## **REMARKS**

The Applicants would like to thank the Examiner for carefully reviewing the specification, drawings and claims. The Applicants respectfully request reconsideration of the application in view of the above amendments and the following remarks, which are directed to each of the ground for rejection of objection cited in the Office Action of March 12, 2004.

Fig. 7.

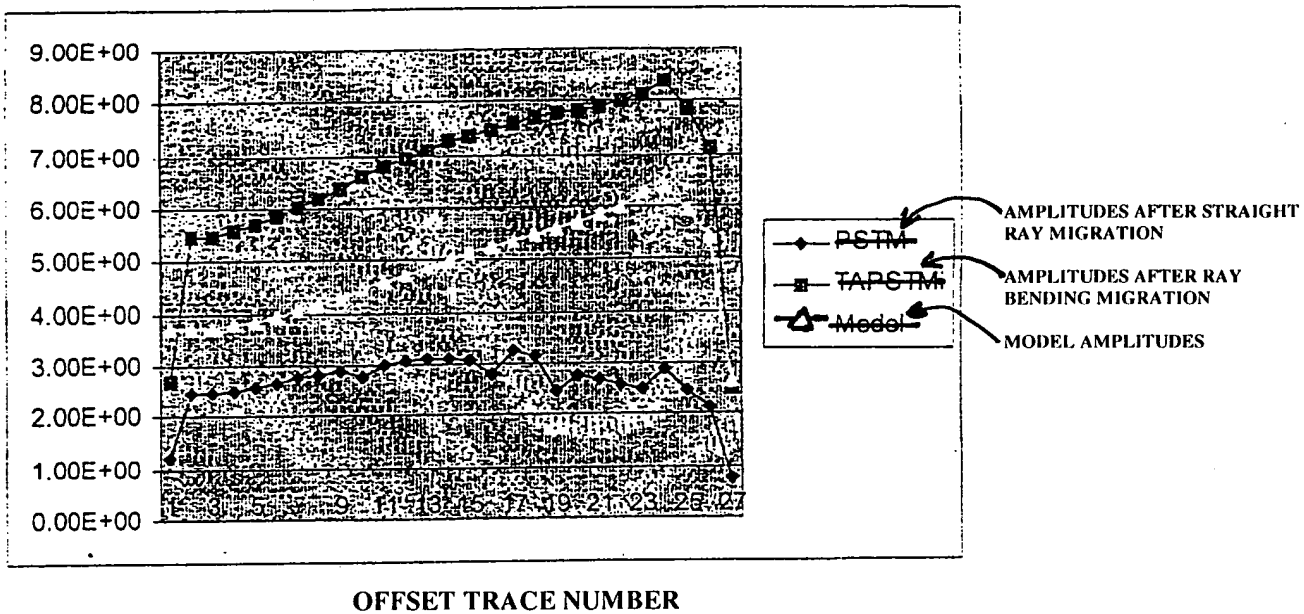
Applicant also notes that Figure 7 has been amended for clarity.
